Supplemental
Office Action Summary

Application No.
09/674,600

Applicant(s)
Camenzind et al.

Attachment

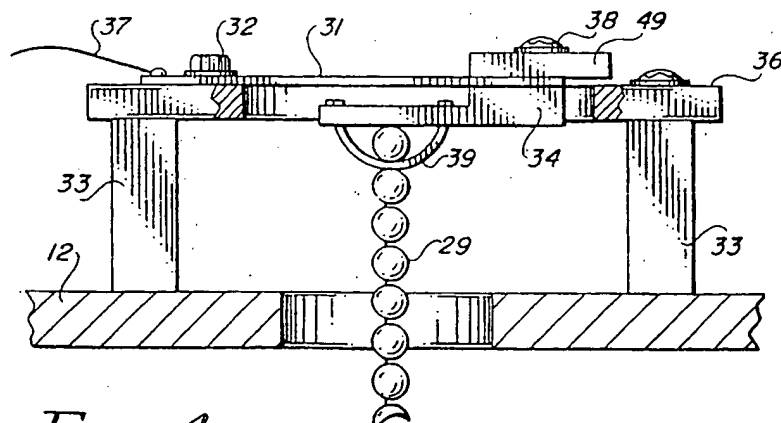
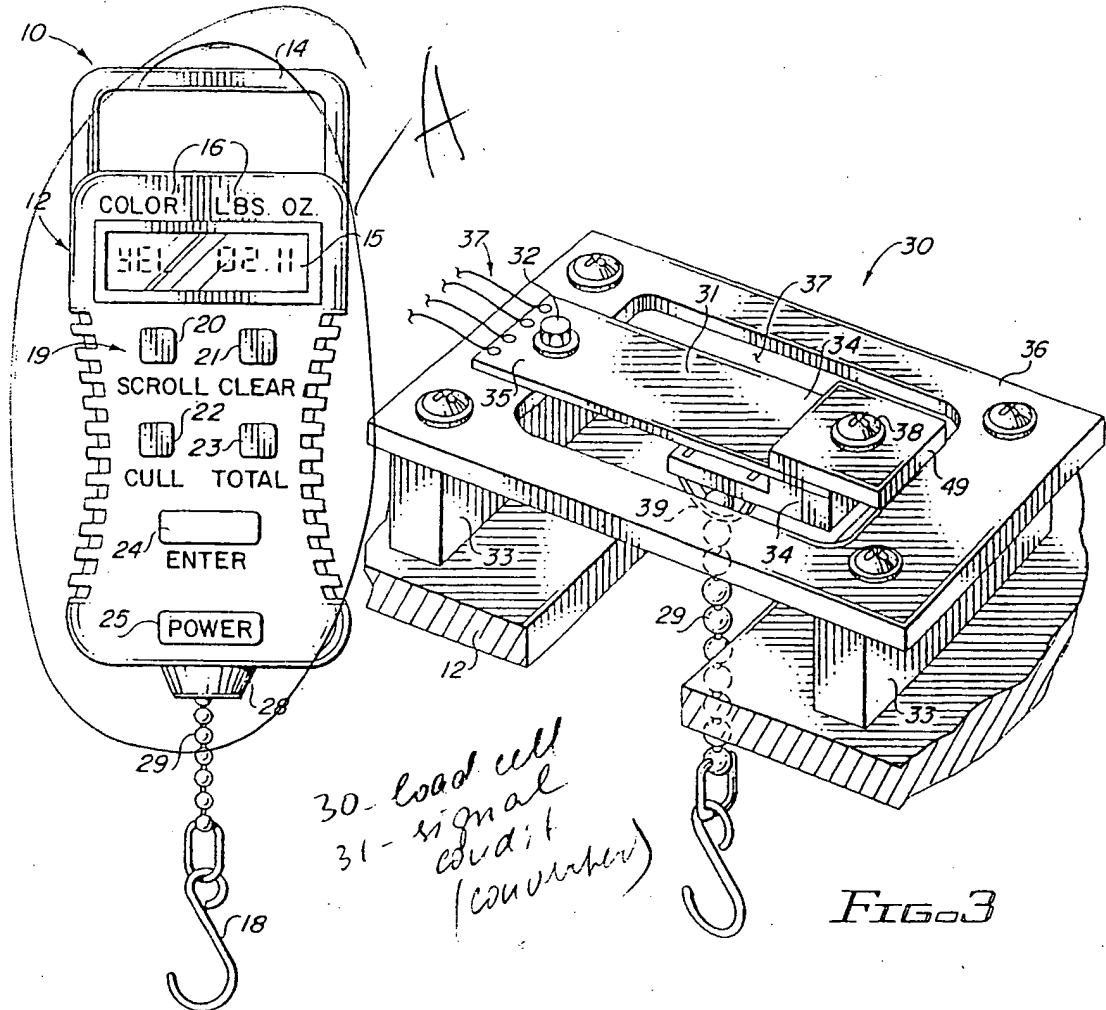
Stanfield discloses a tool (scale) 10 comprising a weighting hook (mechanical hand tool) 18 integrally attached by a hook and loop connection to a measuring and displaying device A, a load cell (measuring sensor/ scale/ weighting cell responding to a pressure) 30, a keypad 19, an electronics comprising a memory (storage device) to store data, a signal conditioning block (converter) 51 for converting a signal (weight/ physical value) in an electrical signal understandable by a processor (microprocessor) 52 which converts the signal in an electronic signal displayed on the display in appropriate units (pounds) on an LCD 15. The electronics is mounted integrally (hook and loop connection) to the hand tool (hook) and can be released. The device can be on/ off. The device is operated by a power supply in a form of battery. (the numeral A has been added by the Examiner, see attachment to the Office Action).
